PLAN AND ZONING COMMISSION

Meeting Agenda
Tuesday, September 17, 2024
6:30 PM

2. Kimberley Villas - Updated Building Elevations

Agenda Item: Kimberley Villas – Updated Building Elevations
Report Date: September 12, 2024
Prepared by: Bryan Morrissey *EJC*
Associate Planner

SCALE: 1/4"=1'-0" AT 22"X34" LAYOUT 1/8"=1'-0" AT 11"X11" LAYOUT

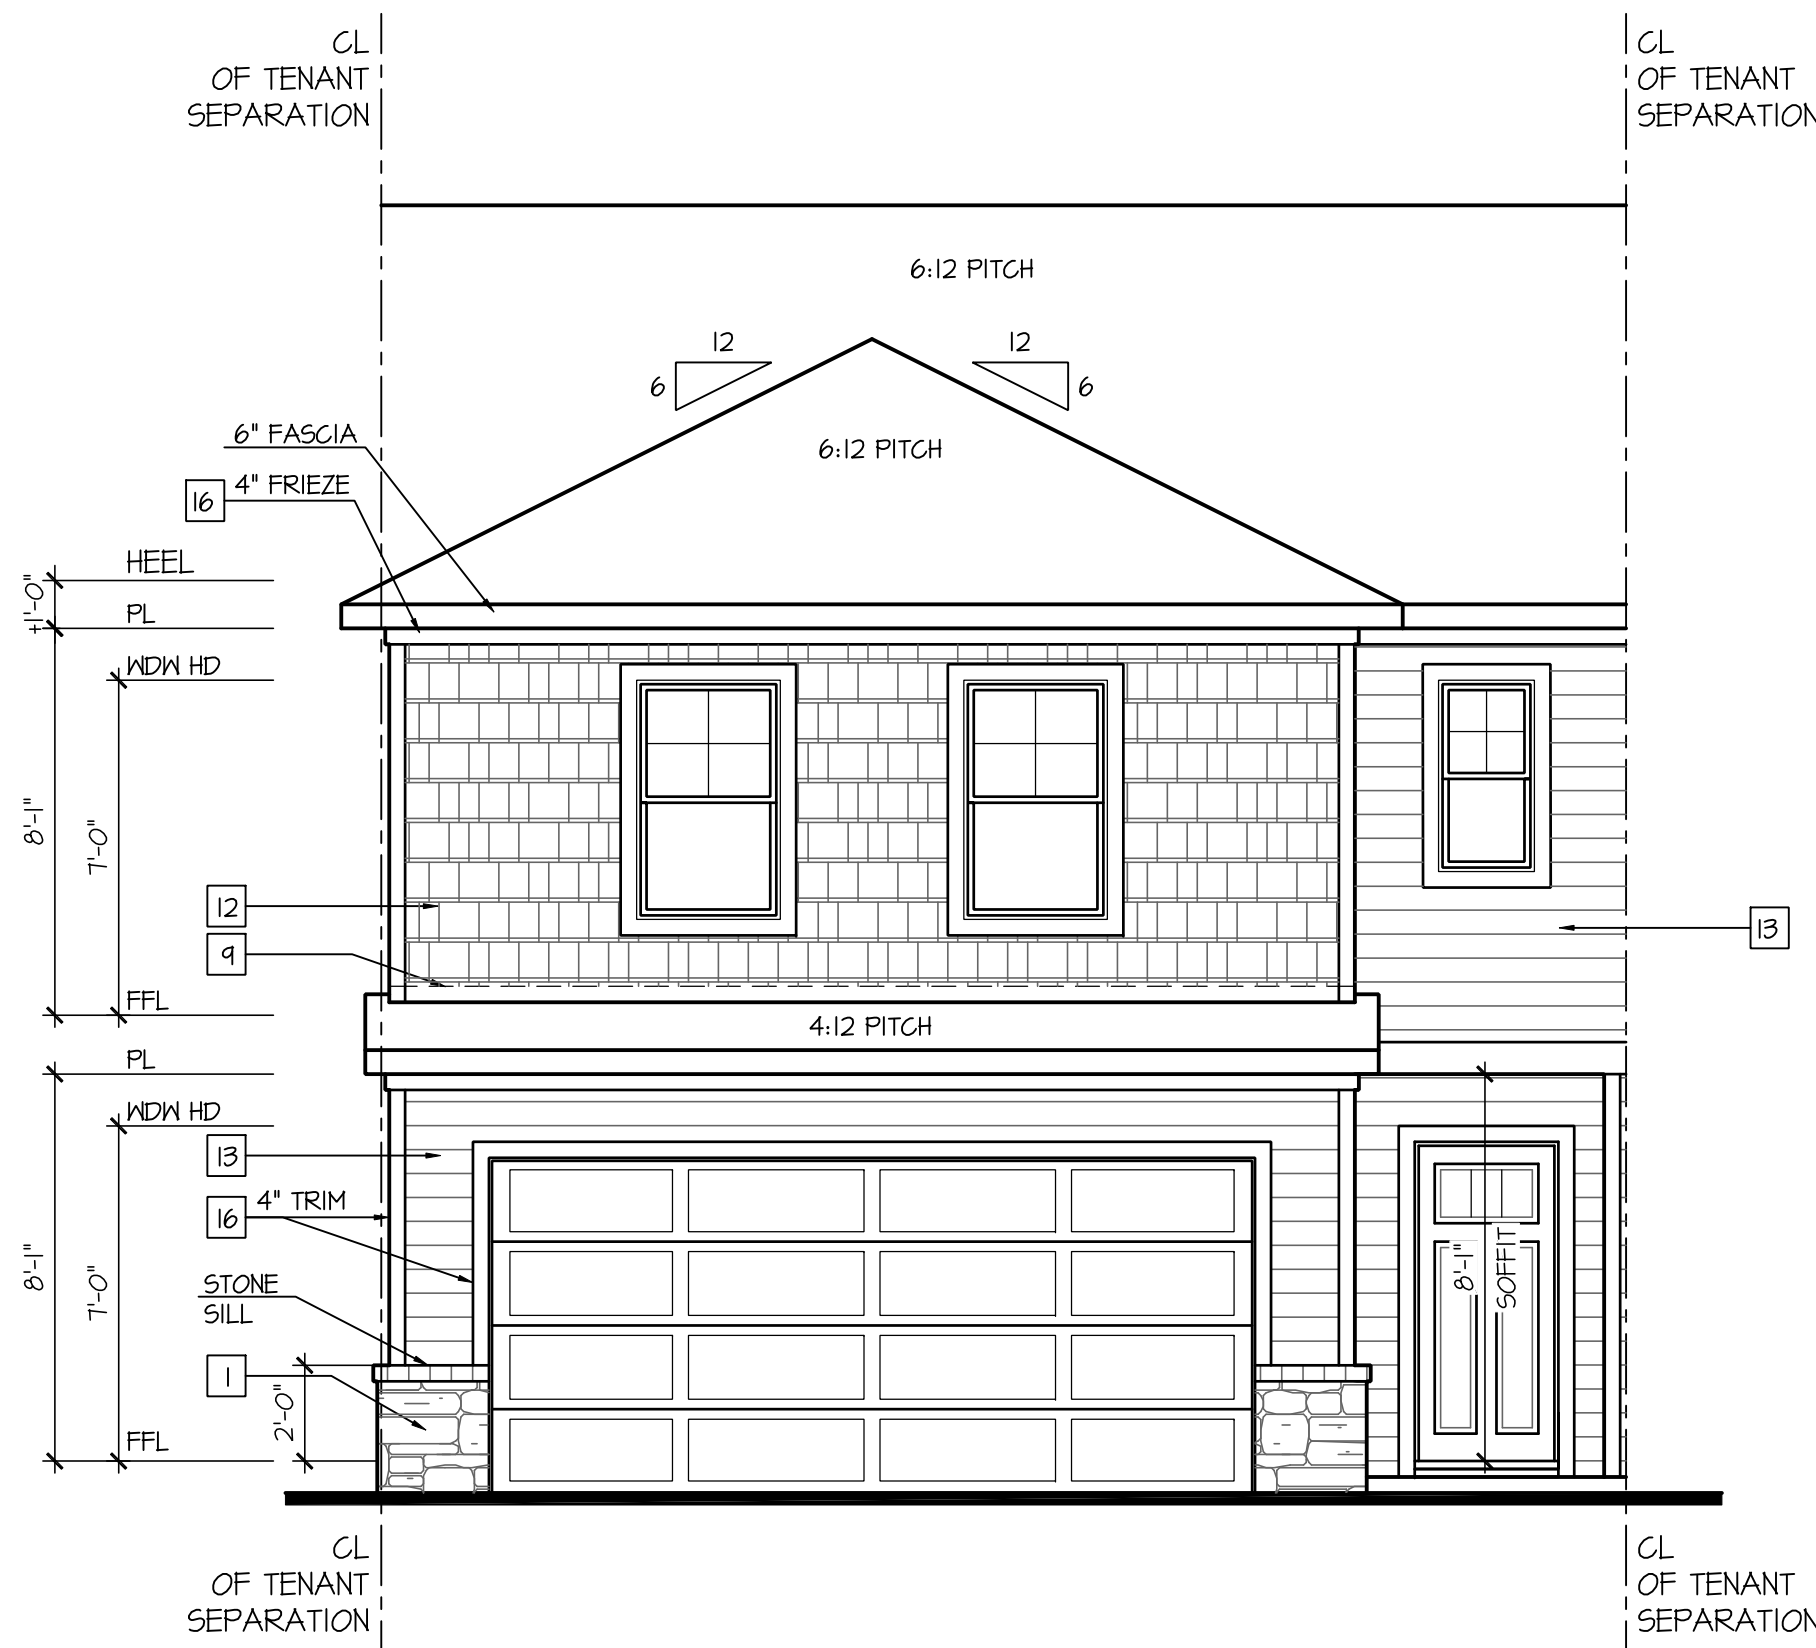
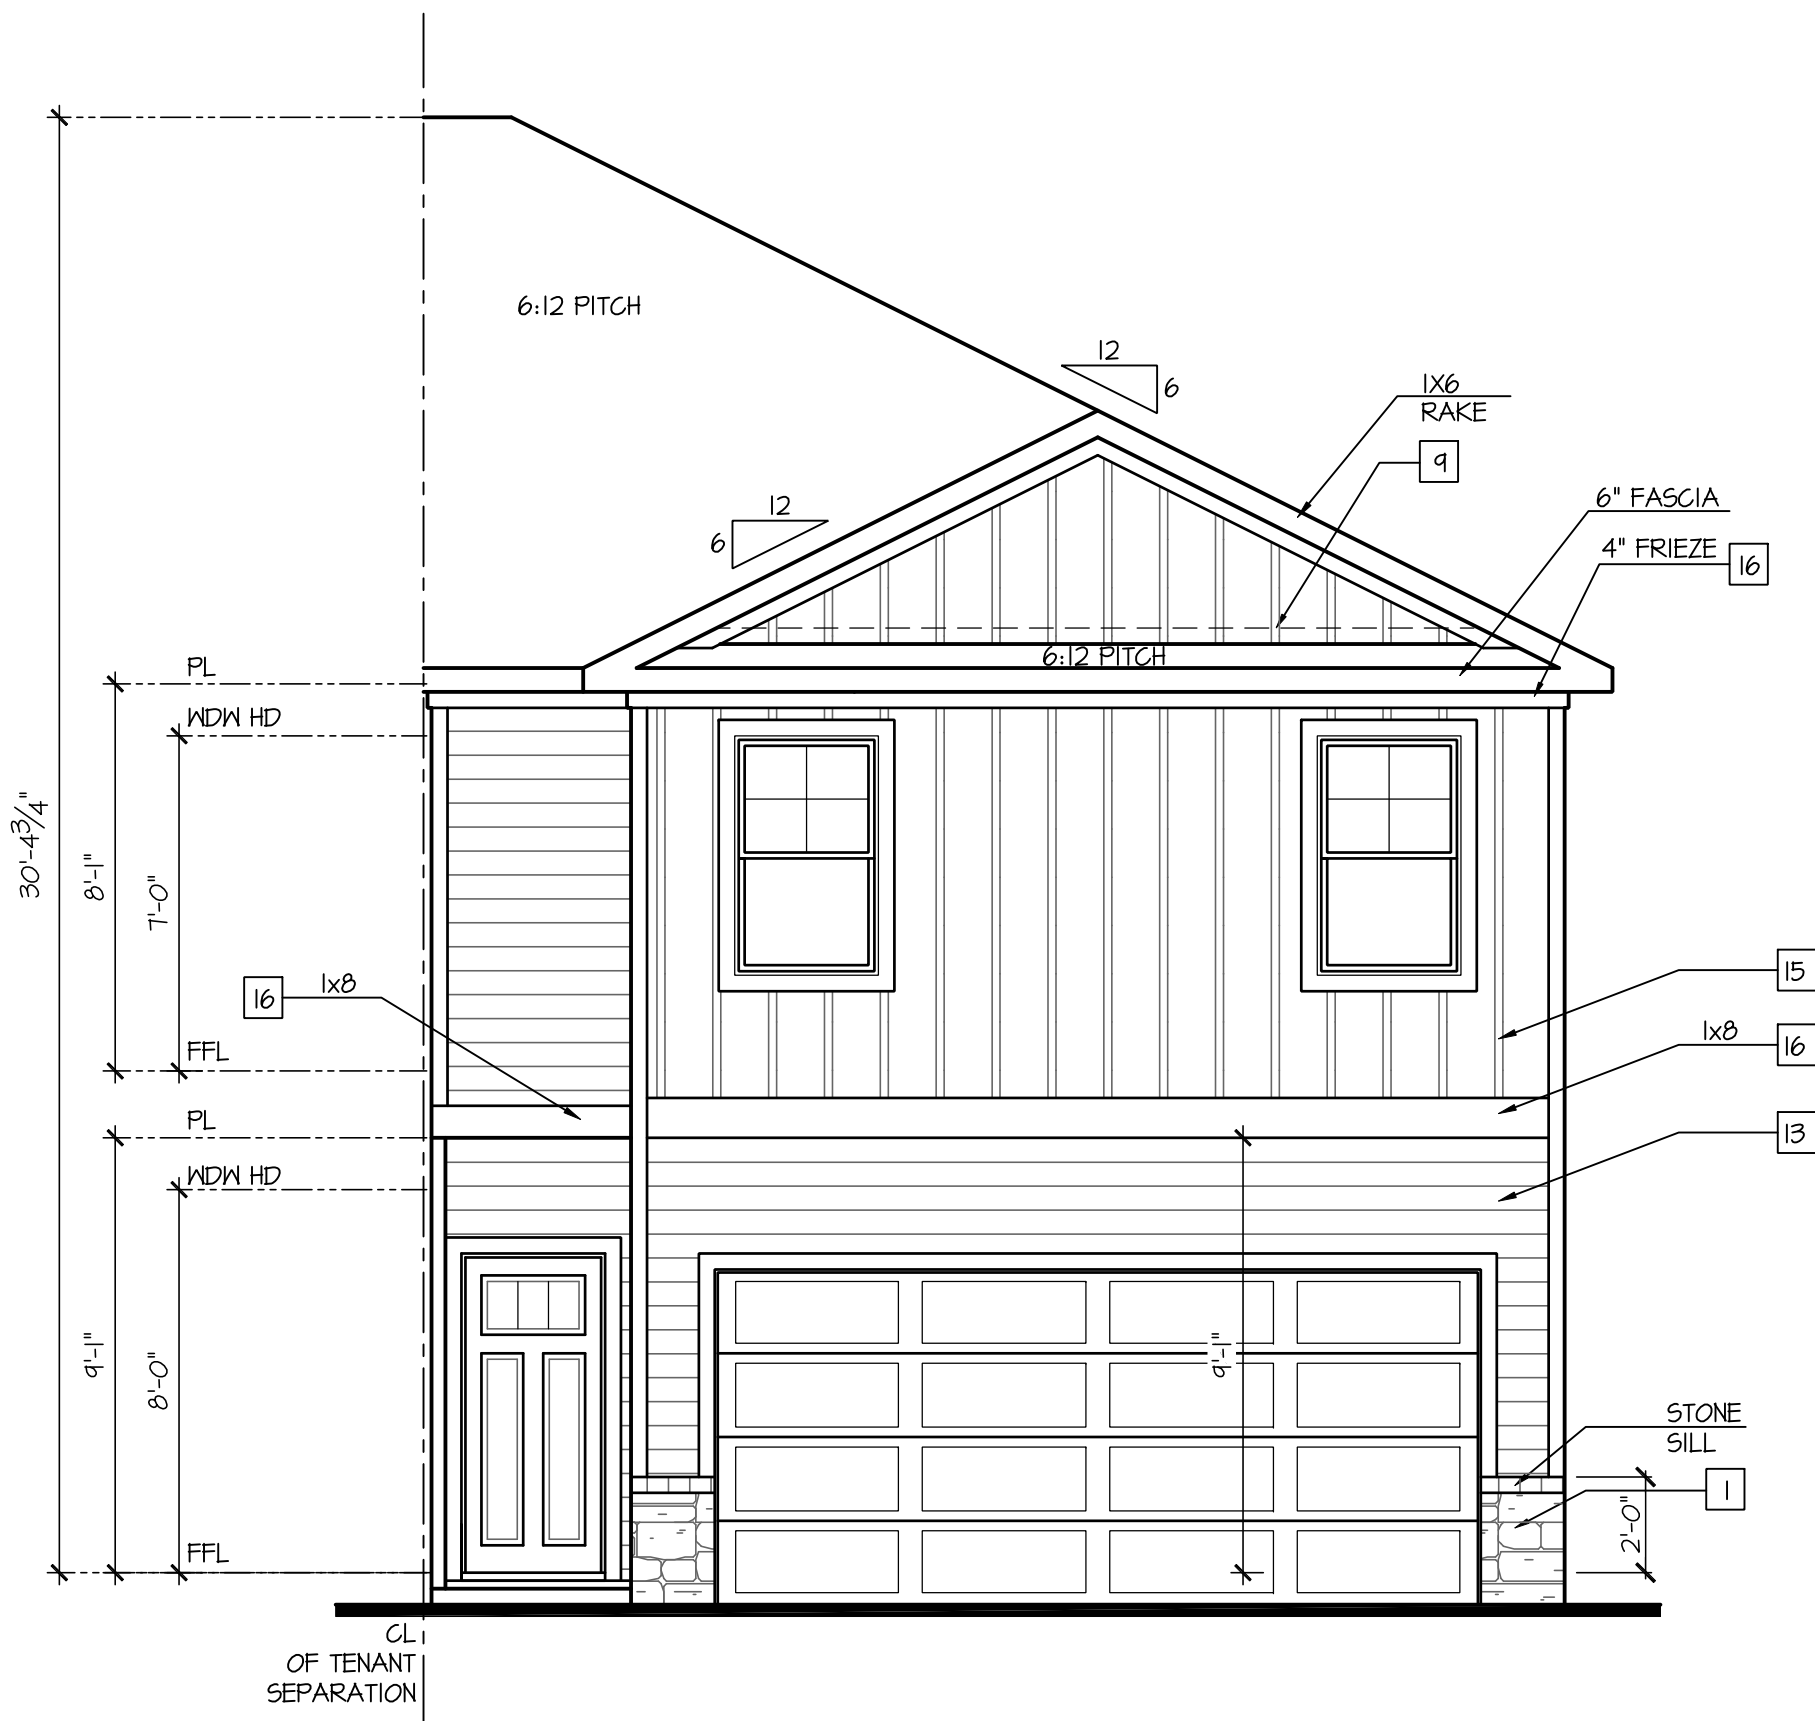
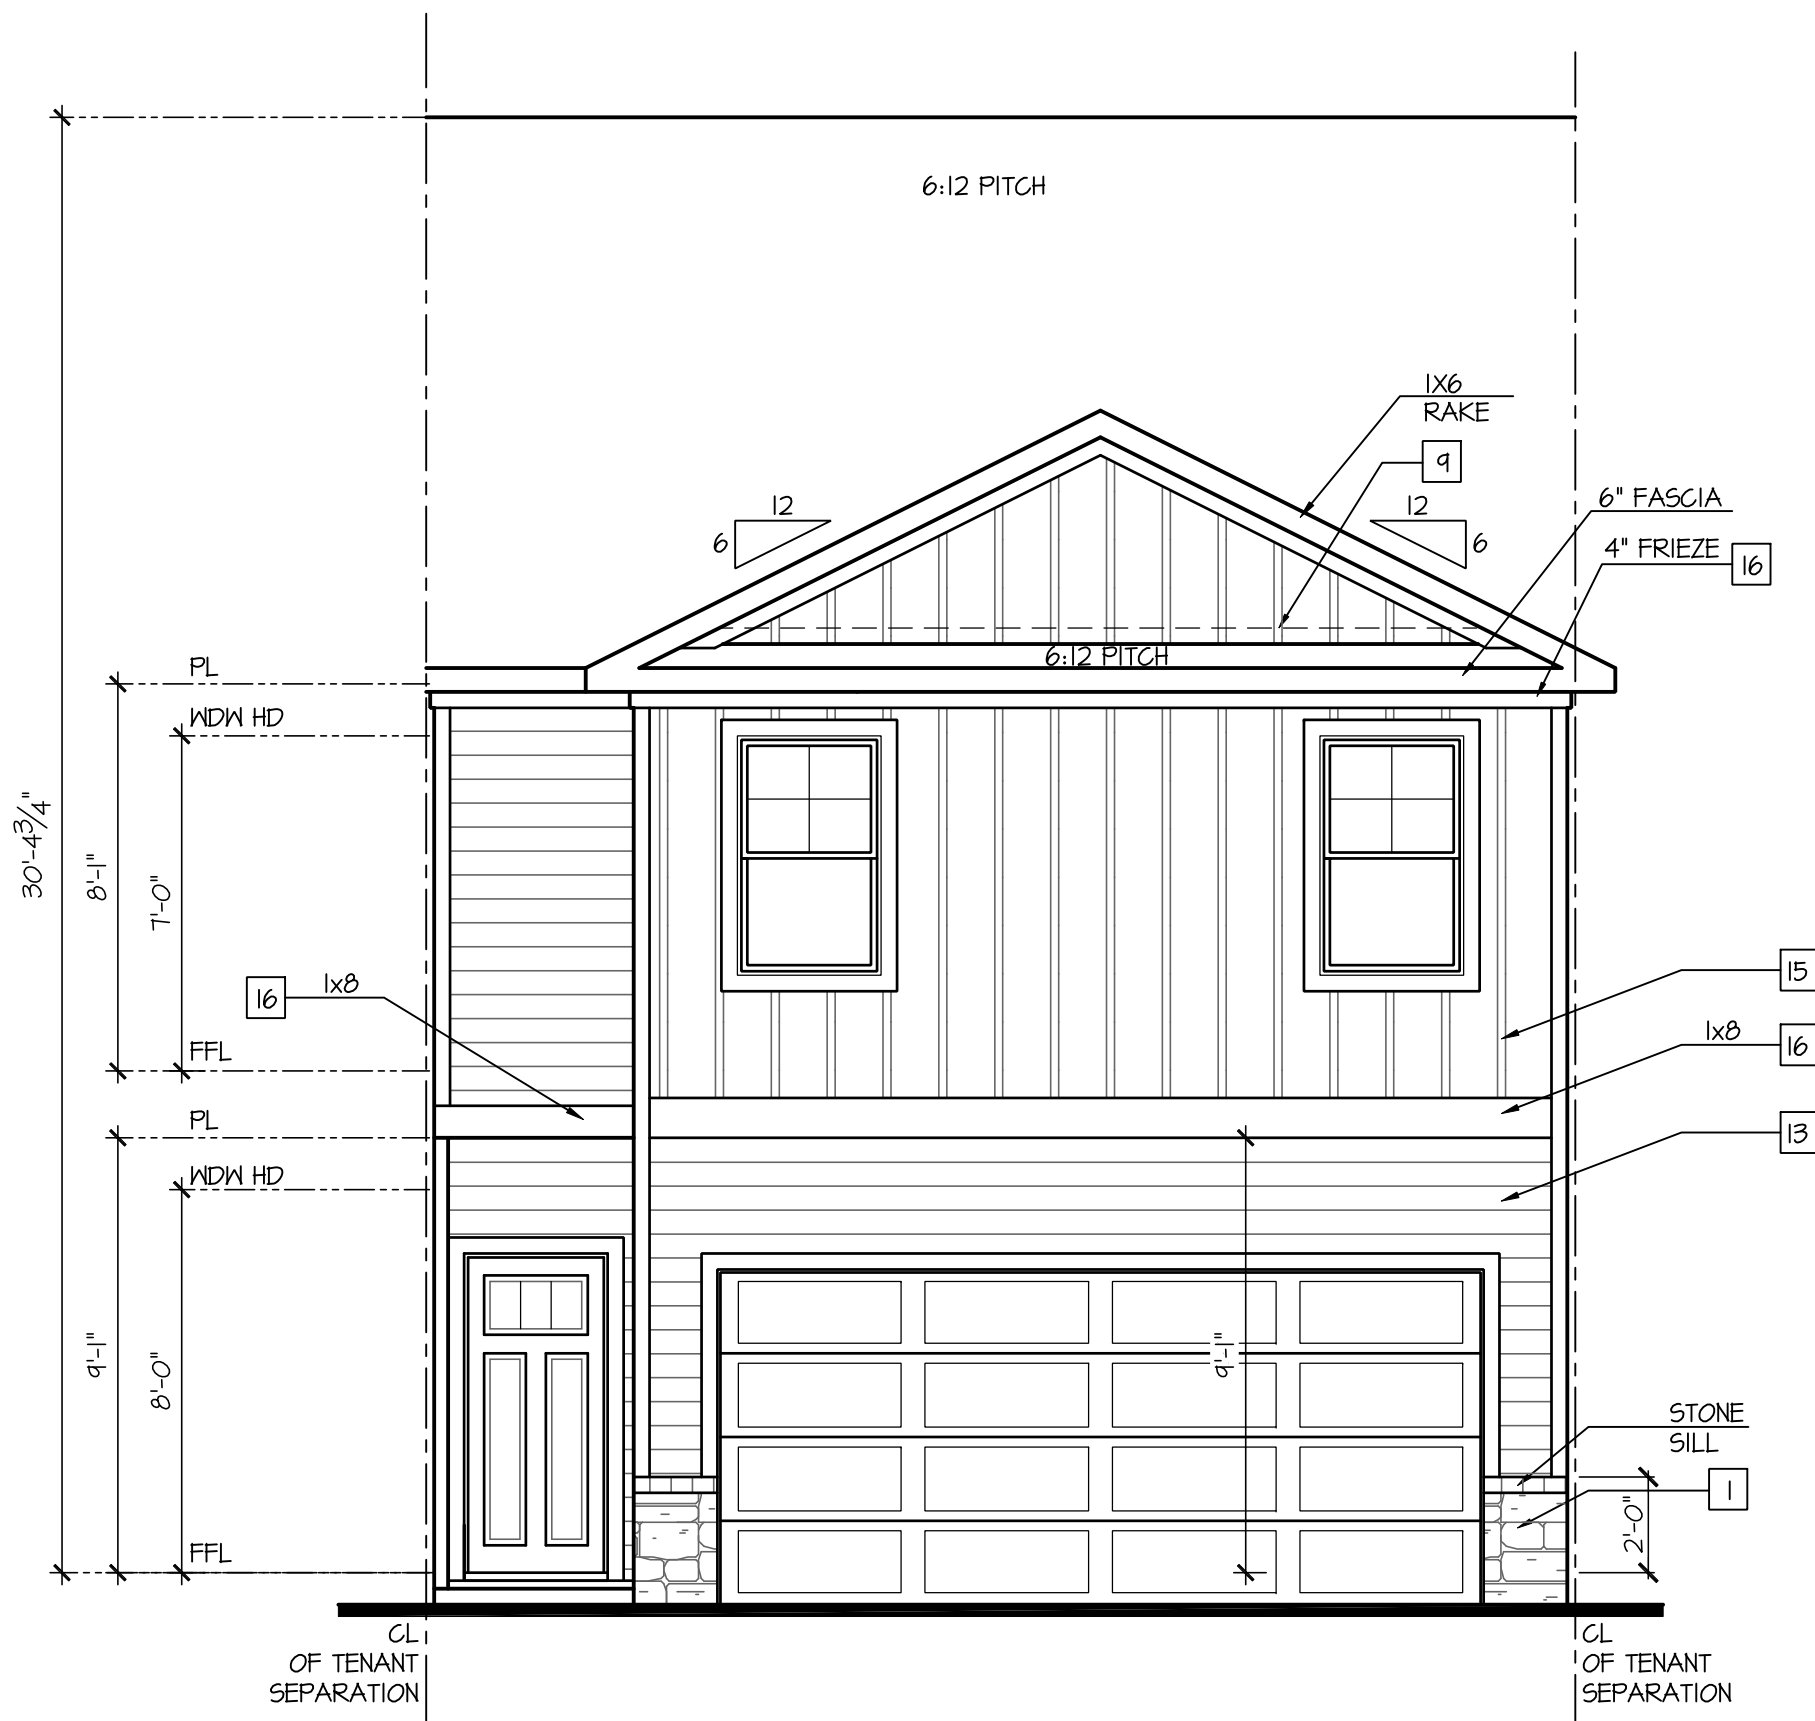
The original building elevations for the townhome units that were approved with the site plan showed substantial amounts of permanent materials (masonry) for units that were visible from the public streets that surrounded the development. The permanent materials were included to ensure that the primary material requirements of the Ankeny City Code were being met. Due to a law that was recently passed by the State of Iowa, material requirements for these kind of townhome developments are no longer enforceable by municipalities.

The updated building elevations that are now being proposed show a significant reduction in the permanent materials that were shown on the original elevations. The majority of the townhome units will be comprised primarily of board and batten and lap siding, with a minimal amount of masonry included on the front of the units. The Sydney elevations will be utilized on Plats 2-4 of Kimberley Villas while the Pattison elevations will be utilized on Plat 1. The color scheme for the overall development will largely be the same to avoid a monotonous and repetitive design.

DR Horton is providing you with new plans for the Kimberley Villa Project in Ankeny Iowa. Changes are as listed:

- We will now do a 2ft stone wrap on the garage front of the unit. Note: XT02 will have stone wrapped on the side of the garage as well
- We do a blend of board and batten and shake on the most front façade/pitch to provide architectural distinction
- We will now do LAP siding down the side and back of the units
